# International Isotopes Inc.

Subject: Submittal of Responses to Requests for Additional Information (RAI)  
TAC L32739.

The following document is provided as a response to the US Nuclear Regulatory Commission RAIs pertaining to the International Isotopes Fluorine Products Inc. December 30, 2009 application to license a depleted uranium hexafluoride de-conversion and fluorine extraction process facility.

**Figure 1-3 IIFP Site Map with Surrounding Industrial Properties. Figure 1-3 IIFP General Site Location in Relation to NM Highway 483 and U.S. Highway 62/180**

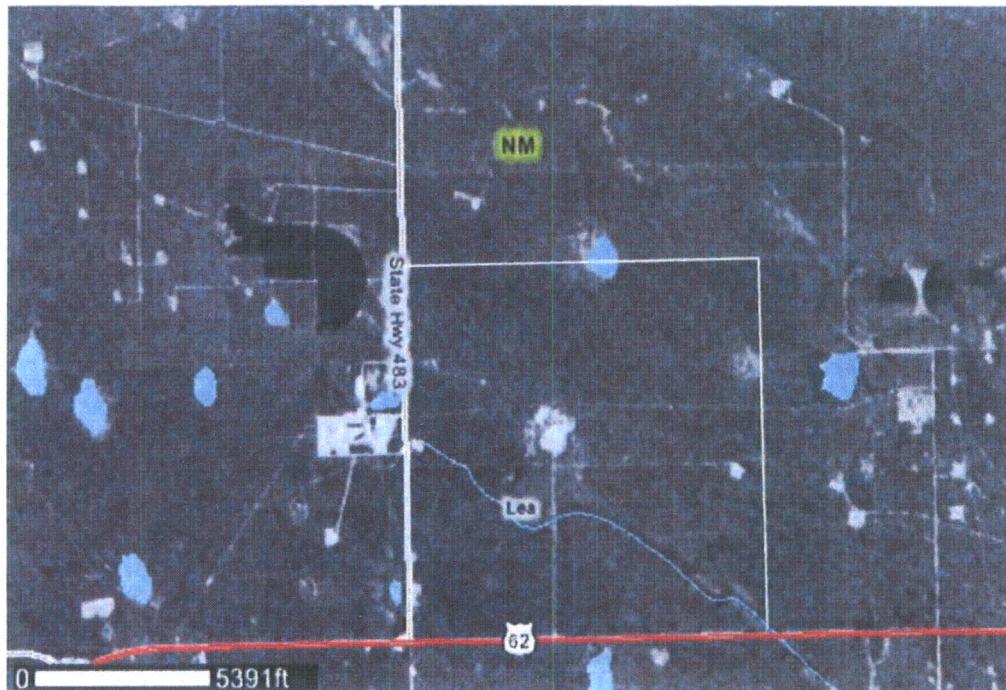
*GI-1 Comparison between the topographical features in License Application (LA) Figures 1-3 and 1-4 gives the impression that the 640-acre plot would extend beyond the county sections represented in Figure 1-4. Consistent with NUREG-1520, Section 1.1.4.3(2), trace out the 640-acre property on LA Figure 1-4, similar to LA Figure 1-3, to clarify how county Sections 26, 27, 34 and 35 overlap with the 640-acre property.*

**RESPONSE:** The site proposed by the Lea County Economic Development Council consisted of four (4) 640-acre Sections from which INIS would select one section on which to build the IIFP Facility. The intent of the original Figure 1-3 in Chapter 1 of the IIFP License Application was to show the general area in relation to Highways 62/180 and 483. At the time that Figure 1-3 was developed, the exact boundaries had not been clearly defined. The Figure 1-3 outline boundaries shown on the map should have been updated to be correct and consistent with the later information used in the updated correct Figure 1-4.

**License Documentation Impact:** Figure 1-3 in the License Application Revision A, Chapter 1, Section 1.1.1 will be replaced with the revised Figure 1-3 below. Also, paragraph three of the Section 1.1.1 will be revised to read as follows:

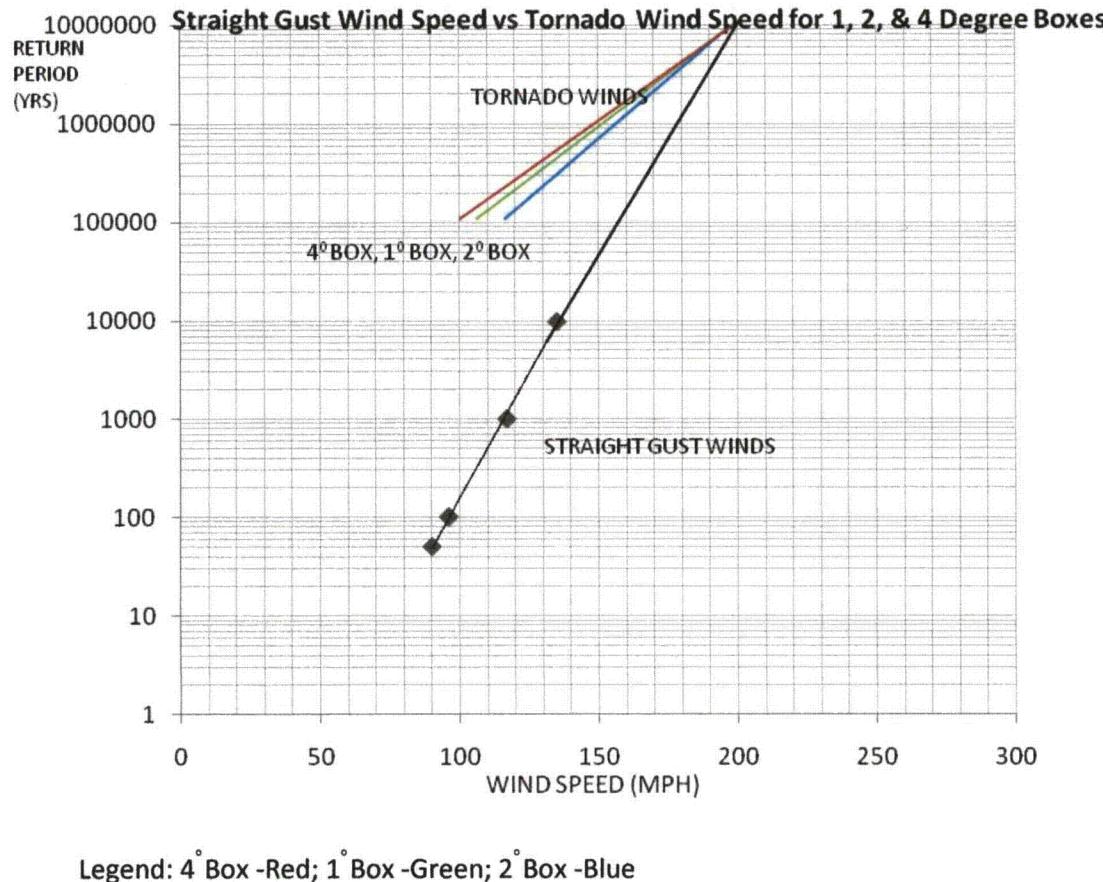
D. For the design basis wind strength in the ISA Summary, provide a return year period and maximum wind speed for both intermediate term (100-500 years) and long term (>1000 years). Specify the basis for both the maximum wind speed and return year period for the information, e.g., a site-specific study, national weather service, etc. In addition, Table 3-22 in the ER has a very limited timeframe (82-97). Justify that this limited timeframe is adequate for the design basis wind. Demonstrate that the wind assessments were from a recognized source and the method used for analyzing high-wind hazard is a commonly used and accepted method.

**RESPONSE:** The determination of design basis wind speed has been reevaluated using a different methodology and under a different set of criteria than those addressed in Question GI-10 D. A discussion of that methodology is provided in this response.

The evaluation of tornadoes and straight winds was made based on NUREG/CR-4461, Revision 2 (February, 2007) including data in Appendices A, B and C of the NUREG. This NUREG guide provides calculations based upon 46,800 tornado segments occurring from January 1, 1950 through August 2003 of which more than 39,600 had sufficient information on location, intensity, length, and width to be used in the analysis included in this report. NUREG/CR-4461, Revision 1 had been published in April 2005. The National Weather Service changed from using the Fujita Scale to the Enhanced Fujita Scale in February 2007. Revision 2 incorporates the Enhanced Fujita Scale in its methodology and calculations. Specifically, Chapter 5 of the NUREG has been revised to show  $1 \times 10^3$ ,  $1 \times 10^6$ , and  $1 \times 10^7$  probability design wind speeds (i.e., probability of exceeding that wind speed in one year) for the contiguous United States estimated using the above database and the Enhanced Fujita Scale. (NCDC, 2010b)
